SUBJECT: STAFF OBSERVATIONS OF TESTING FOR GENERIC SAFETY ISSUE 191 DURING MARCH 8 AND MARCH 9 TRIP TO THE ALION HYDRAULICS LABORATORY

OBSERVATIONS OF TESTING

AT ALION SCIENCE AND TECHNOLOGY HYDRAULICS LABORATORY

MARCH 8 AND 9, 2007

Figure 2-Strainers in Plywood Enclosure

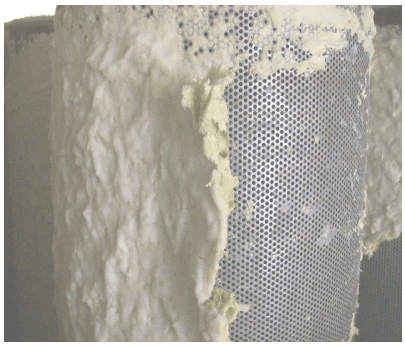
Figures 1 and 2 show the installation of the strainers in the tank. Figure 3 shows a closeup of the perforated strainer surface. All three figures are post-test and show some debris on the strainers' surfaces. Some debris has apparently fallen off of the strainers following the test and subsequent drain down of the tank. Figure 4 shows the bypass eliminator that has been removed from the strainer internals following the test. Figure 5 shows the top surface of a strainer with some debris settled on it.

- The configuration of the wooden enclosure around the strainers may have resulted in preferential loading of the front two top hats/modules and more likely the front surfaces of these two top hats. Based upon previous staff experience, this may have been a small effect for this test and may even be typical of loading of the outside strainers in the plant. However, this effect should be considered in the design of the test protocol.

Figure 4-Bypass Eliminators

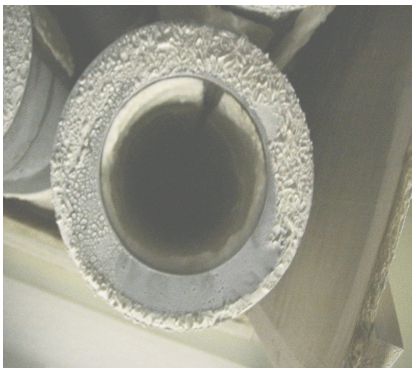
The strainers contained a fiber bypass prevention material which consisted of layers of metallic mesh. This is a feature currently employed on Enercon strainers to reduce the amount of fiber bypassing the strainer and is termed a “bypass eliminator.” The bypass eliminator was previously reported as being somewhat effective in removing debris that had bypassed the perforated plate in an NRC Alion Laboratory trip report dated June 27, 2006, (ML061720514). Figure 4 (in the test results section) shows some of the mesh removed from the strainers that were used in the test that is the subject of this report. There is some debris apparent on the mesh.
